ALERT SERVICE BULLETIN

WIRING CHANGES TO KING AUDIO SYSTEM INSTALLATION (KNA – 20) TO PREVENT INADVERTENT RADIO TRANSMISSIONS (CO G50)

Figure 2

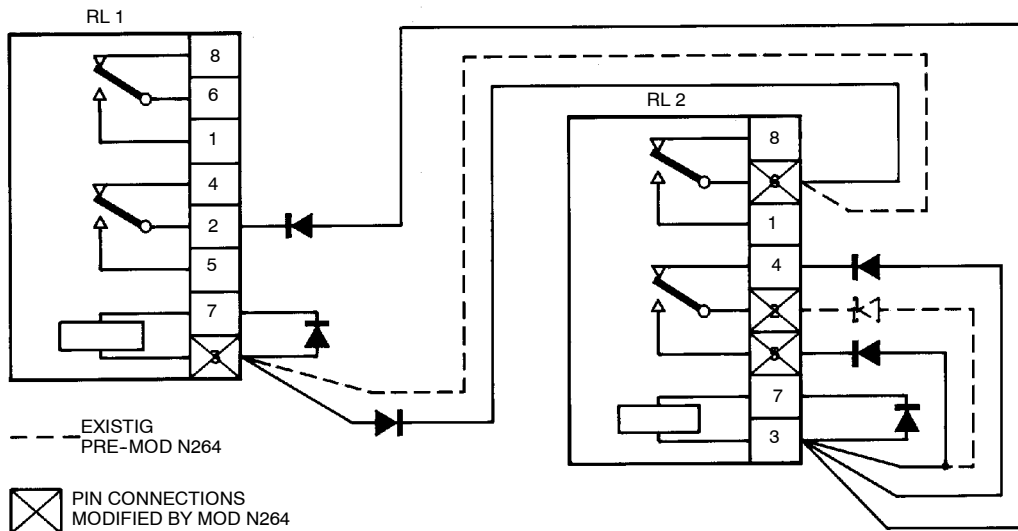
An existing wire between two relays is removed and replaced by a diode. A diode on one relay is rewired to prevent erroneous operation during the relay pull in.

- D. Unfasten the cover over the plug and unscrew relay bracket to gain access. Refer Fig. 2.
- E. Unplug relays from the mounting socket to prevent relay damage during rework of relay wiring.

- F. Remove the wire from relay one socket pin 3 (RL1/3) to relay 2 socket pin 6 (RL2/6). Install diode (IN645 or IN646) between RL2/6 and RL1/3 with the anode at RL1/3 Ref., Fig. 2.
- G. On RL2 transfer the diode attachment wire on Pin 2 to Pin 5 with the anode connection retained at Pin 3. Ref. Fig. 2.
- H. Carry out continuity checks and functionally test.
- I. Reassemble/refit relays 1 and 2, connector, KMA 20 and instrument panel.
- J. Functionally check flight controls for range and freedom of movement
